UNITED STATES PATENT AND TRADEMARK OFFICE

APPLICATION NO.	FILING DATE	FIRST NAMED INVENTOR	ATTORNEY DOCKET NO.	CONFIRMATION NO.
10/755,356	01/13/2004	Motoari Ota	0649-0933P	9821
2292 7590 05/08/2007 BIRCH STEWART KOLASCH & BIRCH PO BOX 747 FALLS CHURCH, VA 22040-0747			EXAMINER HOLT, DAVID L	
			ART UNIT 2609	PAPER NUMBER
			NOTIFICATION DATE 05/08/2007	DELIVERY MODE ELECTRONIC

Office Action Summary

DETAILED ACTION

Fig. 12

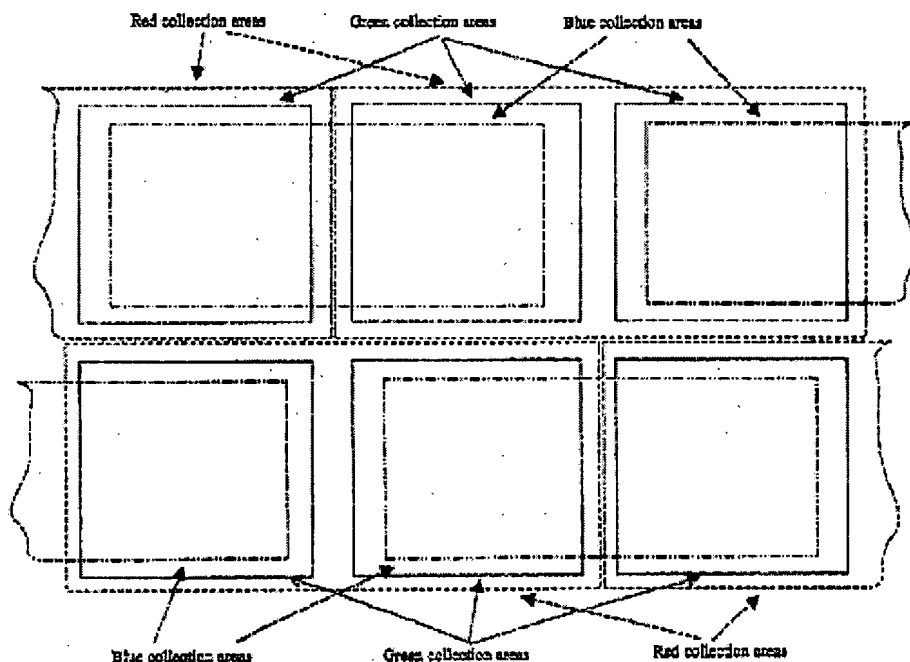
Limitations (d), (e), and (f) of claim 2 are all taught by Turner in Figure 12 of the prior art. Any single "collection area" of a specific color, e.g. a "green collection area," teaches limitation (d). Any combination of two "collection areas" of two different colors teaches limitations (e) and (f). In this analysis, the word "area" is considered a synonym of "region," where region can be defined as a large, usually continuous segment of a surface or space.

12. Claim 6, viewed in light of claims 2 and 5, shares the limitations of claim 5, discussed above, and adds the limitation: the first spectral sensitivity corresponds to a spectral sensitivity of a green color. As mentioned above, Figure 12 discloses a "green collection area" that teaches limitation (d) of claim 2 as well as satisfies this additional limitation of claim 6.

FIG. 1

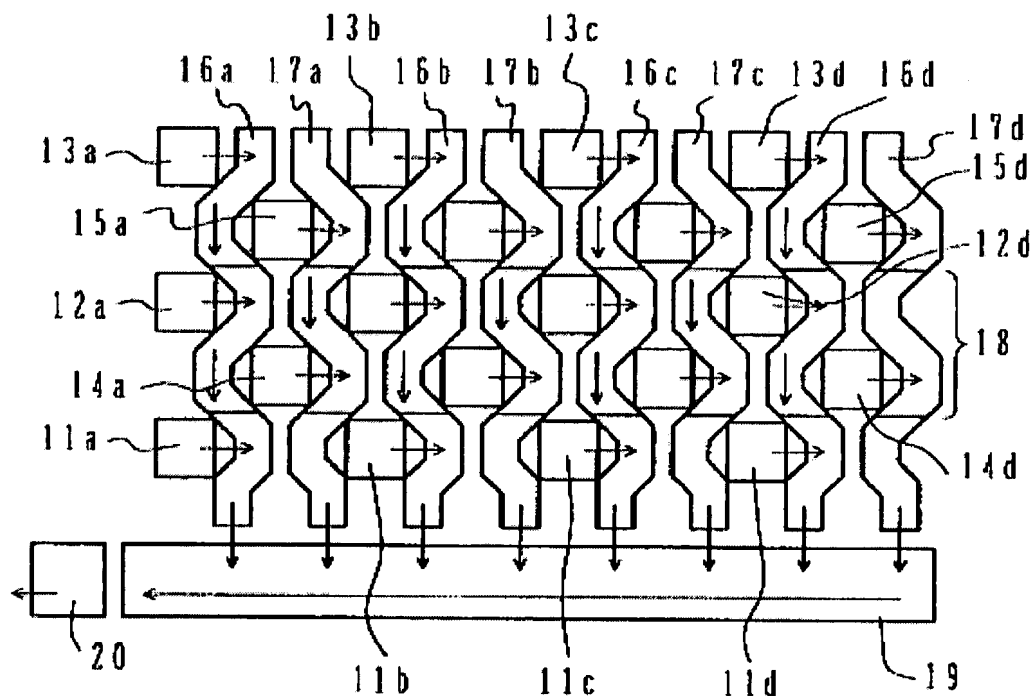
Yamada, like Turner, teaches a solid-state image pickup device, but focuses his invention on "a novel layout of its components." Figure 1 clearly shows the limitations: a vertical transfer portion (16a), corresponding to limitation (g); a horizontal transfer portion (19), corresponding to limitation (h); and an output portion (20), corresponding to limitation (i).

Yamada, like Turner, teaches a solid-state image pickup device, but focuses his invention on "a novel layout of its components." Figure 1 clearly shows a honeycomb layout of photosensitive regions (11a-d, 12a-d, 13a-d, 14a-d) that matches the layout described in limitation (j).

Yamada, like Turner, teaches a solid-state image pickup device, but focuses his invention on "a novel layout of its components." Figure 1 clearly shows a honeycomb layout of photosensitive regions (11a-d, 12a-d, 13a-d, 14a-d) that matches the layout described in limitation (j).
